NAVSHIPS 0967-035-6020

ELECTRONICS FIELD CHANGE BULLETIN 1- TH-39A/UGT
BUREAU OF SHIPS NAVY DEPARTMENT
WASHINGTON, D. C.

MODIFICATION TO SUPPRESS SPURIOUS EMISSIONS
FROM THE TH-39A/UGT CW OSCILLATOR CIRCUIT

TEMPORARY CORRECTION TO TECHNICAL MANUAL (IN-2025) FOR TONE
INTELLIGENCE UNIT MODEL TIS-3 (Military Designation:
TH-39A/UGT)

Bottom View of Chassis

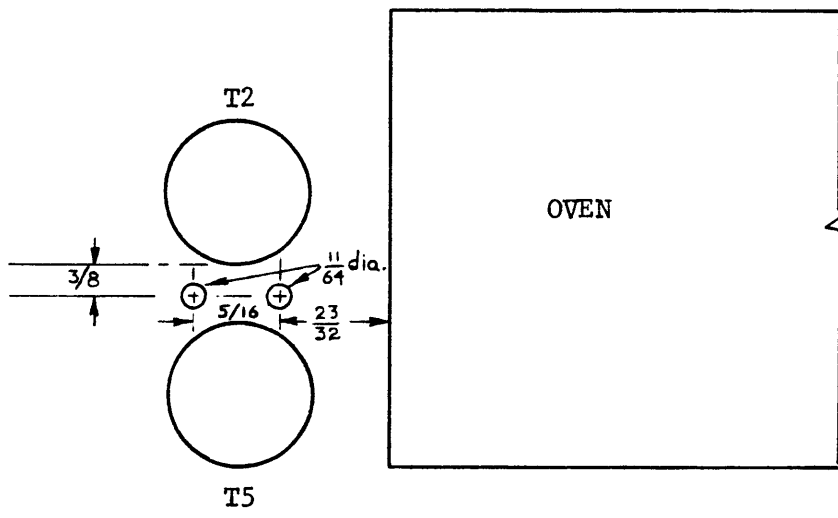
1. Set B+ switch at OFF.
2. Unplug a-c power cable from J1 of TIS.
3. Disconnect terminal strip from E3 on rear of TIS.
4. Place TIS on workbench.
5. Remove top and bottom covers from TIS.
6. Remove 0.04-uf capacitor (C23) and 22-Ohm resistor (R46).
7. In place of resistor removed in step 2, solder 1,000-ohm resistor, item 2 in table 1.
8. Drill two holes as shown in illustration (Bottom View of Chassis) using electric drill and number 26 drill bit, items 6 and 7 in table 2.

9. Mount terminal board assembly, item 1 in table 1, on bottom of chassis between T2 and T5, using items 5, 6, and 7 in table 1.
10. Solder green lead of terminal board assembly to turret terminal from which C23 was removed.

11. Solder black lead of terminal board assembly to nearest grounded terminal.
12. Solder red lead of terminal board assembly to terminal 7 of audio transformer (T2)

Simplified Schematic Correction

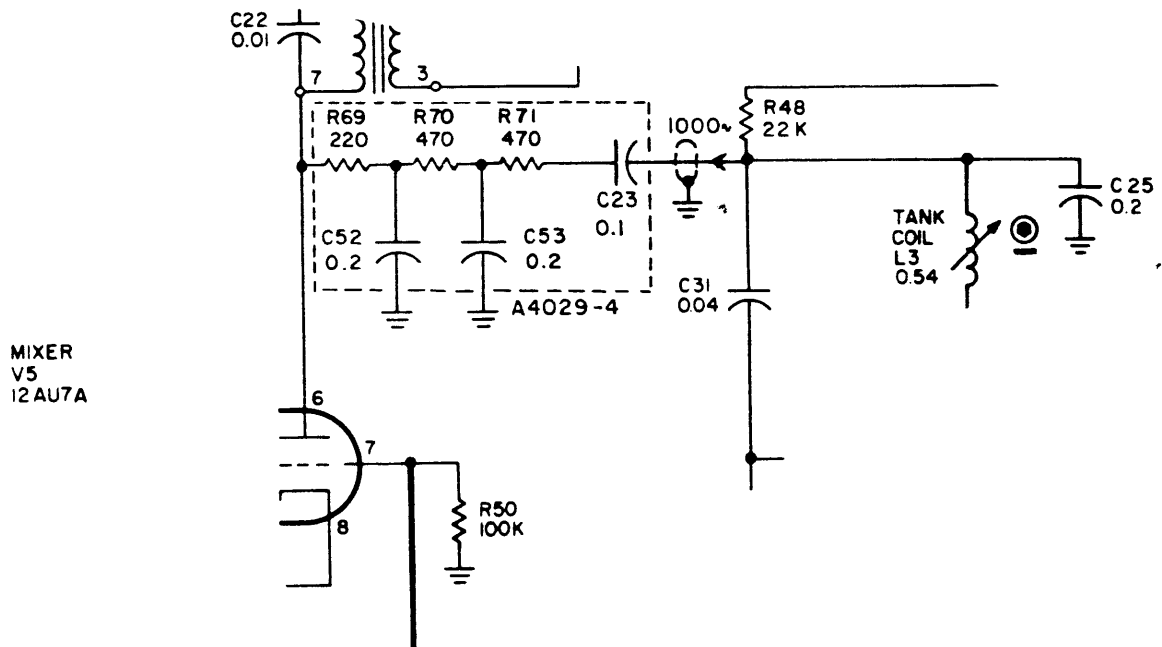
1. Remove figure 8-1, (pp. 8-3/8-4) from TIS-3 manual and insert new figure 8-1 supplied with this temporary correction. Keep old figure 8-1 intact for support of equipments that have not been modified.
2. On figure 4-6, page 4-9, change value of R46 from 220 to 1k (1,000 ohms).
3. Make a sketch to record the position and connections of C23 as shown on figure 4-6. Retain this sketch in support of equipments that have not been modified.
4. Cut out and paste Simplified Schematic Correction, supplied with this temporary correction, over the appropriate area of figure 4-6.
5. In parts list, page 7-5:
 - (a) Change C23 description to read: CAPACITOR, fixed: mylar; 0.1 mfd. Change TMC PART NO. to read CN114R102J.
 - (b) Change R46 description to read: RESISTOR, fixed: composition; 1,000 ohms, \pm 10%, 1/2 watt. Change TMC PART NO. To: RC20GF102K.

Cut out and paste over appropriate
area of figure 4-6, page 4-9 in
TIS-3 manual.
